AFTER SALES SERVICE
Service Instruction Sheet

Product group: Electric Tool
Bulletin No: 2022.01.00000001
Created on: 07/09/2022
Published: Internally¹ Distributors² Sales companies³ Dealers⁴ Service Centers⁵
Subject: Different Motor & Electronic (Switch) used in Production on RBC36X26B & RBC36X26E

Affected Tools:

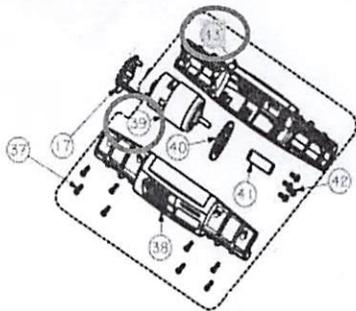
On the Zero Brush Cutter "RBC36X26 was introduced a new Electronic Switch 5131035037 & a new (longer) Motor in Production, from old Motor 5131035048 to new Motor 5131041267.

old Motor 5131035048 switch to new

Motor 5131041267 (pos. 39) + new Housing 5131035051 (pos. 43)

Solution for old Motor repair: In case of a Motor exchange on Code 5131035048 please use new Motor Code 5131041267 in addition with the Housings, 5131035051

(In Code 5131035051 are both Housing halves (left + right) included)

Affected Electronic: 5131035037

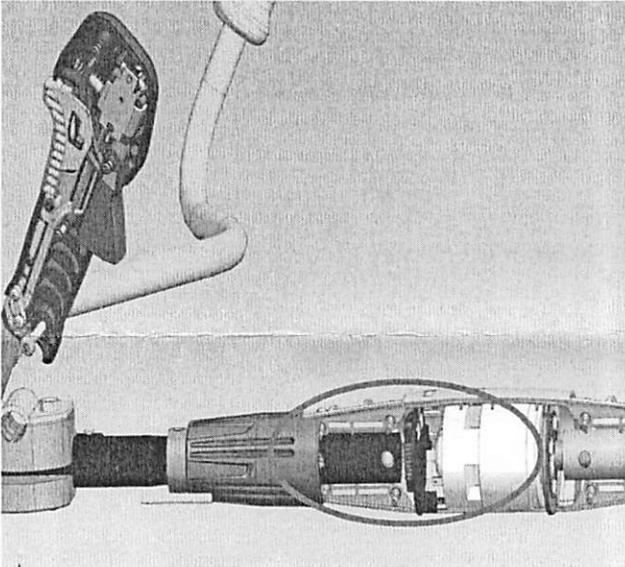
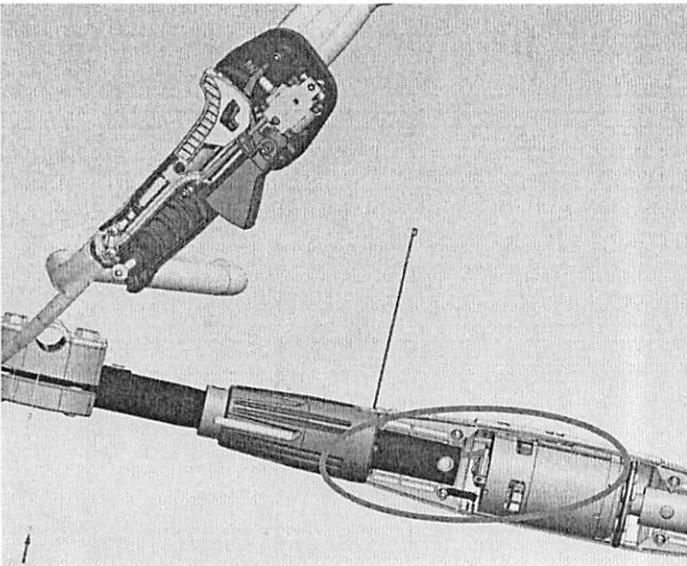
Old design of Switch directly on the Motor:

New design of switch directly on the Handle and cables to the motor.

*Platine entfernen,
ist im neuen
Gehäuse enthalten.*

In case of electrical switch **5131035037** exchange,
it's mandatory to use also the new Motor Code **5131041267**
in addition, with the new Housings, **5131035051** & **5131035047**.
